SUBJECT: RIVER BEND STATION, UNIT 1 - AMENDMENT NO. 93 TO FACILITY  
OPERATING LICENSE NO. NPF-47 (TAC NO. M97834)

ENTERGY GULF STATES, INC. \*\*  
CAJUN ELECTRIC POWER COOPERATIVE AND  
ENTERGY OPERATIONS, INC.  
DOCKET NO. 50-458  
RIVER BEND STATION, UNIT 1  
AMENDMENT TO FACILITY OPERATING LICENSE

SAFETY EVALUATION BY THE OFFICE OF NUCLEAR REACTOR REGULATION  
RELATED TO AMENDMENT NO. 93 TO FACILITY OPERATING LICENSE NO. NPF-47

Figure 3.4.11-1 (page 1 of 1)  
Minimum Temperature Required vs. RCS Pressure

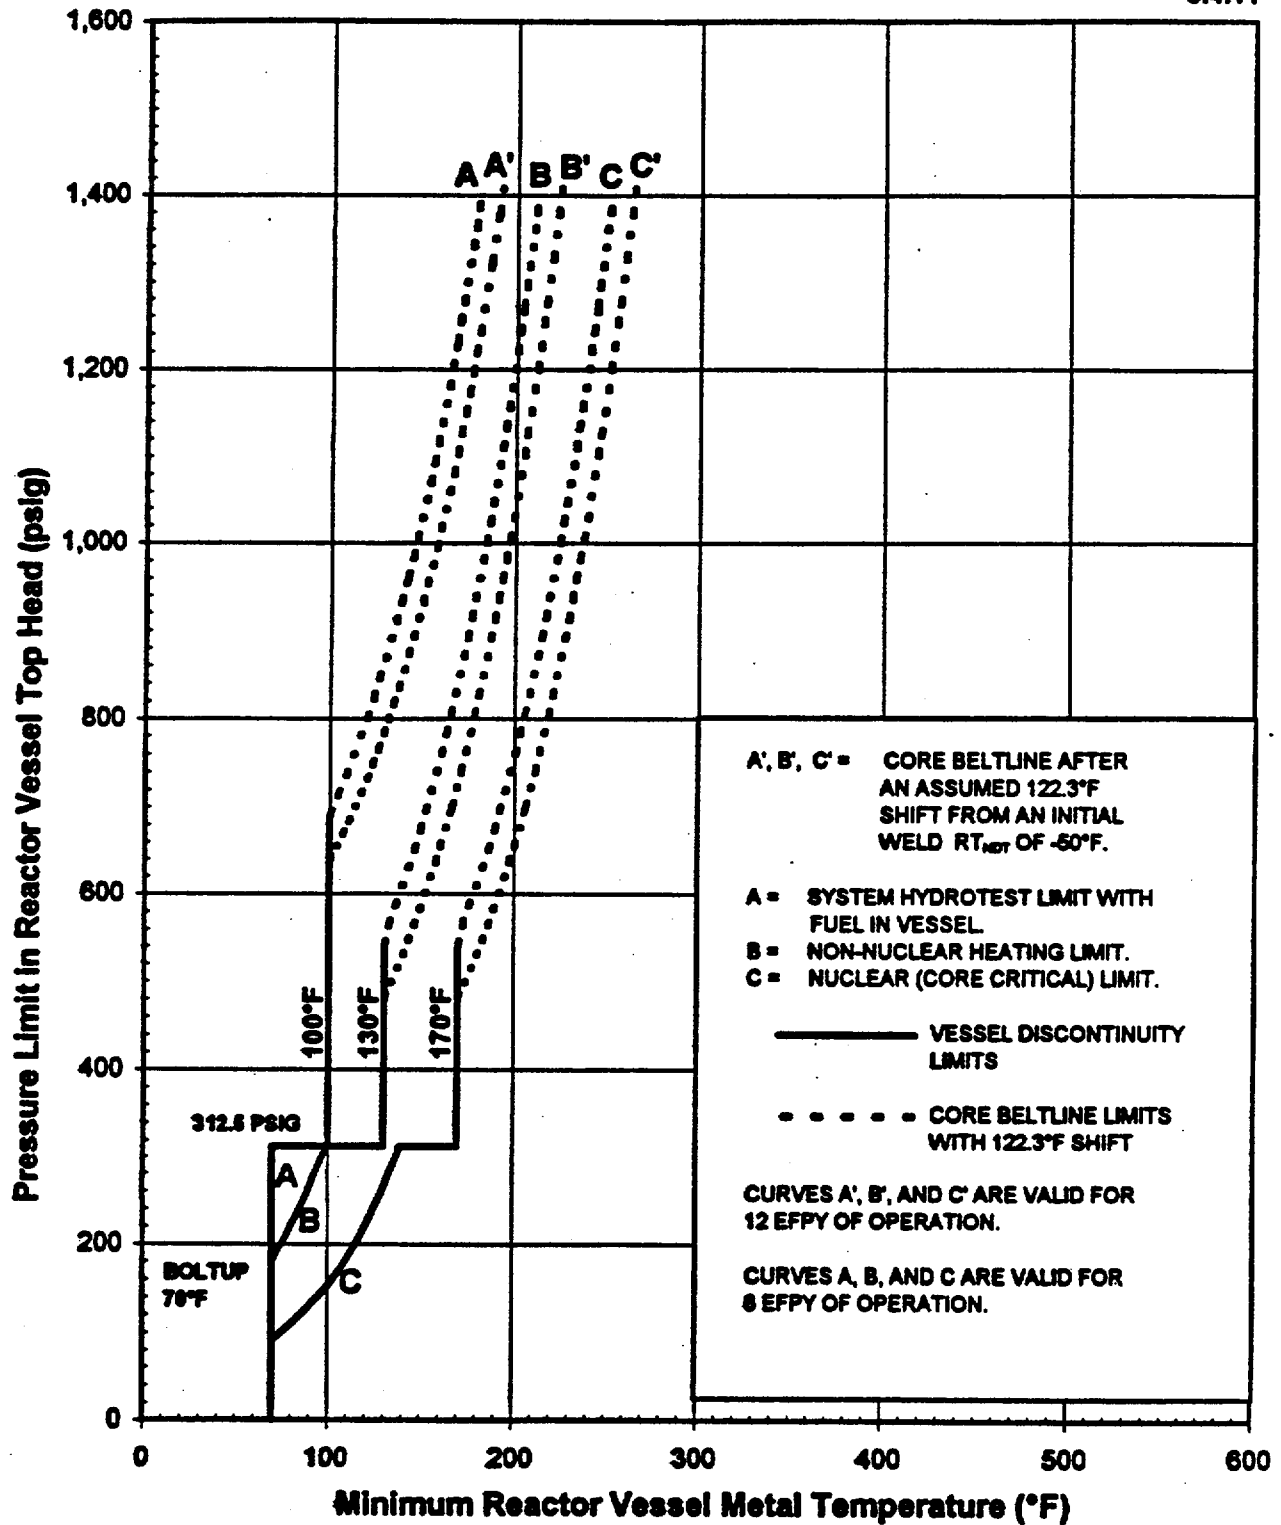
The amendment revises the reactor pressure vessel pressure and temperature limits by providing new limits that are valid to 12 effective full power years.

By application dated January 10, 1997, Entergy Operations, Inc. (the licensee) requested changes to the Technical Specifications (TSs) (Appendix A to Facility Operating License No. NPF-47) for the River Bend Station, Unit 1. The proposed changes would revise the pressure-temperature (P-T) limits for heatup, cooldown, and inservice leak and hydrostatic testing to provide new limits that are valid to 12 effective full power years (EFPY).

For the River Bend Station reactor vessel, the licensee determined that the most limiting material at the 1/4T and 3/4T locations is the axial weld that was fabricated using tandem electrodes. This weld was fabricated using weld wire heat 5P6756. The licensee calculated an ART of 72.3°F at the 1/4T location and 55.2°F at the 3/4T location at 12 EFPY. The neutron fluence used in the ART calculation was  $1.79 \times 10^{18}$  n/cm<sup>2</sup> at the 1/4T location and  $0.93 \times 10^{18}$  n/cm<sup>2</sup> at the 3/4T location. The initial RT<sub>NDT</sub> for the limiting weld was -50°F. The margin term used in calculating the ART for the limiting weld was 56°F.

The staff performed an independent calculation of the ART values for the limiting material using the methodology in RG 1.99, Rev. 2. Based on these calculations, the staff verified that the licensee's limiting material for the River Bend Station reactor vessel is the axial weld that was fabricated using tandem electrodes (heat 5P6756). The staff's calculated ART value for the limiting material agreed with the licensee's calculated ART value.

Substituting the ART values for River Bend Station into equations in SRP 5.3.2, the staff verified that the proposed P-T limits satisfy the requirements in Paragraph IV.A.2 of Appendix G of 10 CFR Part 50.

The staff has performed an independent analysis to verify the licensee's proposed P-T limits. The staff concludes that the proposed P-T limits for heatup, cooldown, inservice leak and hydrostatic testing and core criticality are acceptable to 12 EFPY since the limits conform to the requirements of Appendix G of 10 CFR Part 50 and GL 88-11. Based on the above, the proposed P-T limits and proposed TSs are acceptable.
